From: Mark Record <[REDACTED]@[REDACTED].com>
Sent: 28 June 2021 08:37
To: Richard Burrett <richard.burrett@westsussex.gov.uk>
Subject: ChiCycle concerns over the A29 realignment scheme

[ChiCycle](#) have recently been made aware of the A29 realignment scheme for the land to the north of Eastergate and north-west of Barnham (reference [WSSCC/052/20](#)). We are concerned that such a large amount of money is being focused on providing for unsustainable motor vehicle use during a period of urgent climate crisis. We are also disappointed the proposed walking and cycling infrastructure is of limited scope and of poor quality.

An illustration of where traffic filters could be introduced to improve community living around the old (existing) A29 is shown below:

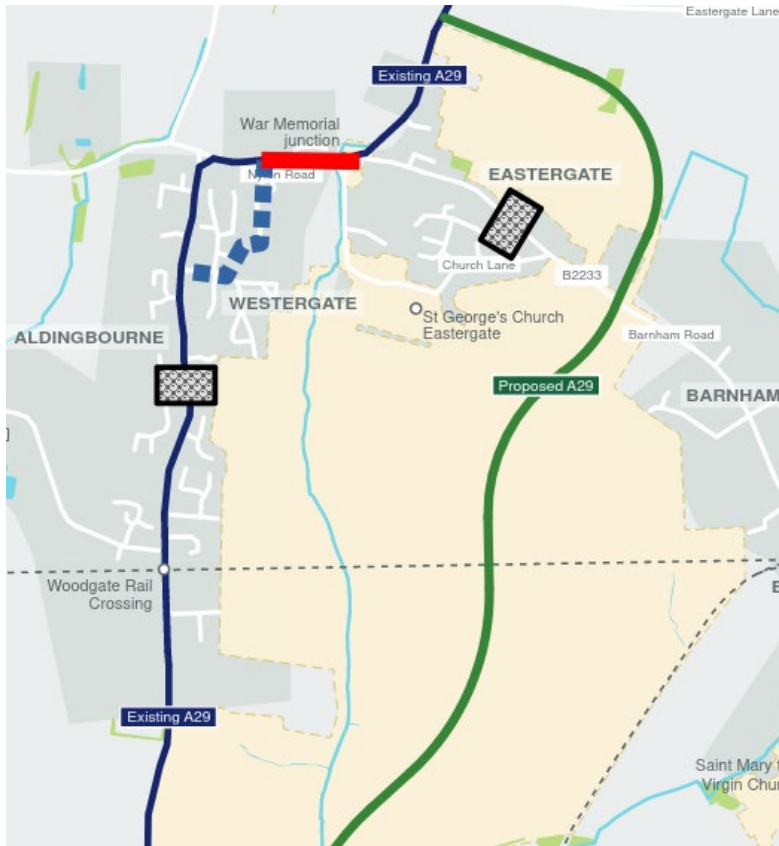
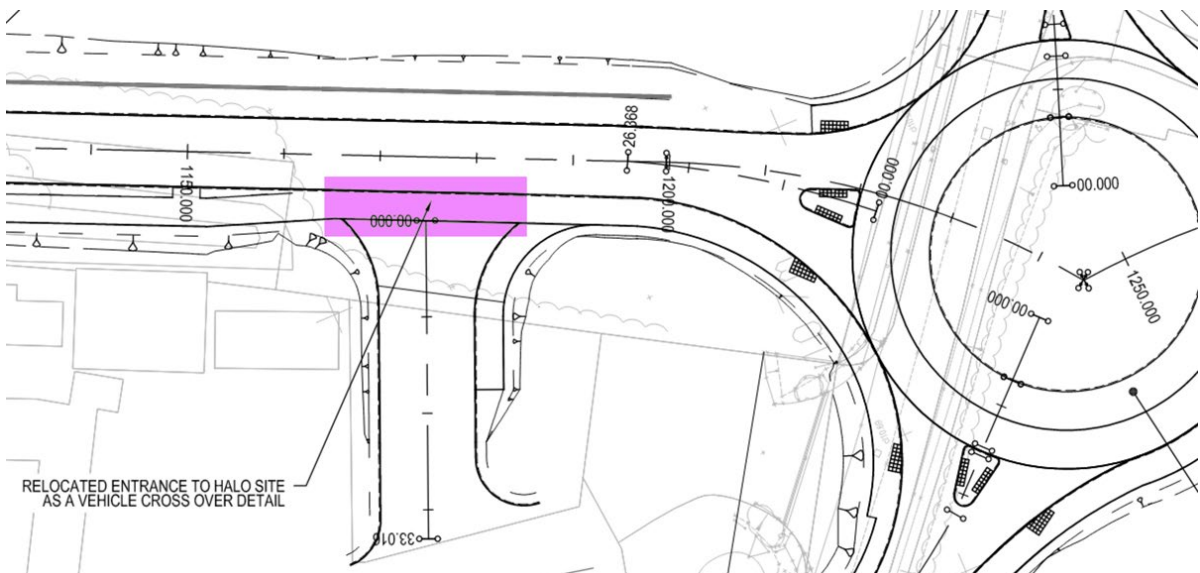
1) If the proposed A29 realignment scheme is considered essential, this additional road construction can only be justified if its environmental impact is offset through encouraging sustainable transport use and local living habits in other locations. Construction of the new route must be met with a parallel intervention to reduce traffic in the residential areas that carry the existing A29 sections that will be bypassed. Failure to implement such traffic reduction measures will result in both the old and the new roads carrying intolerable volumes of traffic well into the future.

ChiCycle recommend private motor vehicles should be restricted (filtered) from travelling through the Westergate section of the existing A29 and the Eastergate Section of the A2233. These traffic reductions should be implemented as soon as the new road is completed. However, pedestrians, local buses, cyclists and emergency vehicles should retain through passage along these streets. This intervention will bring daily traffic volumes through Westergate down from 13,000 vehicles per day to below 2,500. DfT consider that roads carrying 2,500 vehicles a day, with 20 MPH speed restrictions, to have acceptably low volumes of traffic for most people to feel safe while cycling. Not only will such changes permit a significant modal shift towards using sustainable transport but they will permit patterns of healthy local living to become established in these communities. Similar transport interventions have been successfully implemented in the Netherlands resulting in a far higher proportion of journeys made using environmentally responsible modes of transport.

The A29 realignment scheme should not be accepted unless there are agreed plans to convert the previous route of the A29 into a low traffic zone.

In the cross section taken from drawing Cross Sections Sheet 2 of 3 (update).pdf, the lamp posts are shown flush with the edge of the cycle-track. This results in an effective track width of only 2.5 metres, significantly below minimum DfT standards.

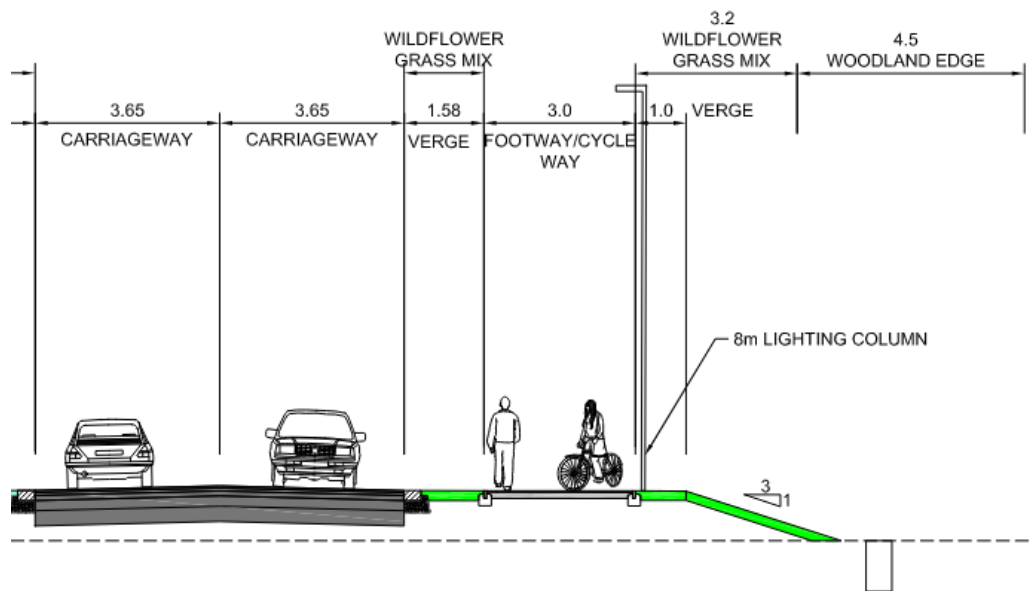
ChiCycle feel that shared use tracks are not appropriate in this urban environment but if they are employed, they should at least meet the minimum widths recommended by current DfT standards.

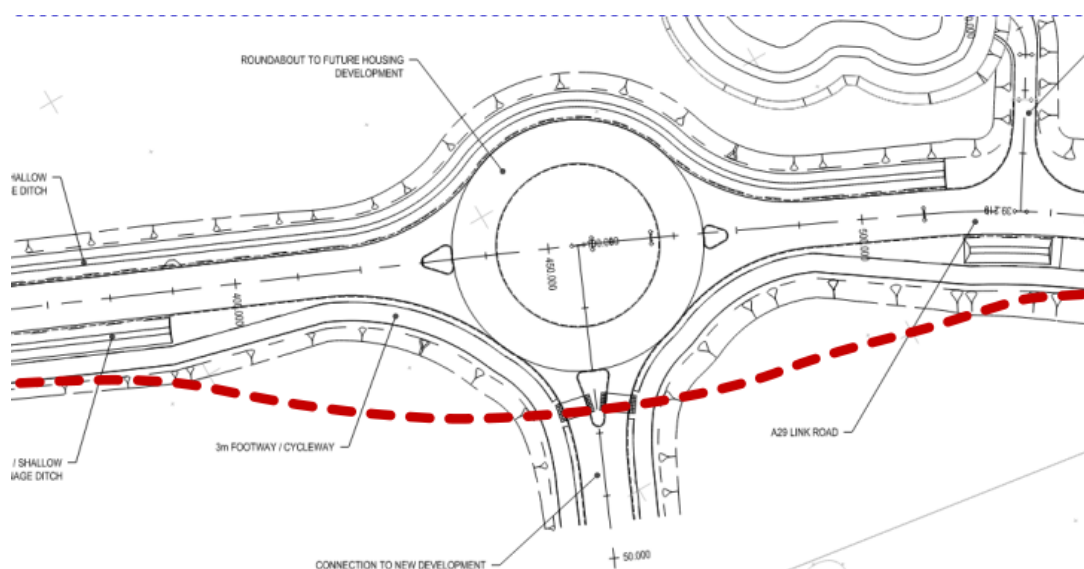
The design of the cycle track around the roundabout (shown below) will force pedestrians and cyclists to first turn in towards the carriageway and then turn out again in the opposite direction through over 90 degrees. This happens twice, on both sides of the roundabout arms crossing. This leaves cyclists heading parallel with the carriageway with the arm leaving the roundabout. When this point is reached, cyclists are expected to make an acute 90 degree to get over the crossing. They presumably are expected to get off their bikes and walk as the crossing provided is not suitable for cycling. The traffic island in the middle of the arm leaving the roundabout looks too narrow even for a standard bike. It is certainly too narrow for cargo bikes or tandems. ChiCycle feel that crossings should be provided that are suitable for cyclists. The illustration below shows the desire line a cyclist would choose to follow in comparison to the path provided by the proposed scheme.
